## **Product Change Notice (PCN)**

PCN Number: PCN-0450022R-01

Product(s) Affected: PJ-074-SMT-TR

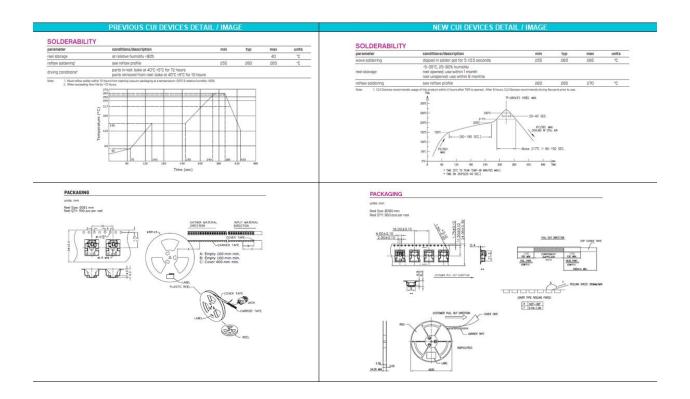
Description of Change: Product re-engineered for improved manufacturability and production yield. See image below as reference for product changes. Cosmetic differences may be visible and do not affect the form, fit or function of the product.

PREVIOUS CUI DEVICES DETAIL / IMAGE				NEW CUI DEVICES DETAIL / IMAGE		
	MATERIAL	PLATING				
terminal 1	brass	gold flash	DESCRIPTION	MATERIAL	PLATING/COLOR	
terminal 2	copper alloy	gold flash	terminal 1	brass	gold flash	
terminal 3	copper alloy	gold flash	terminal 2	copper alloy	gold flash	
plastic	PA6T or equivalent		terminal 3	copper alloy	gold flash	
	o qui raione		housing	PA10T (UL94V-0)	black
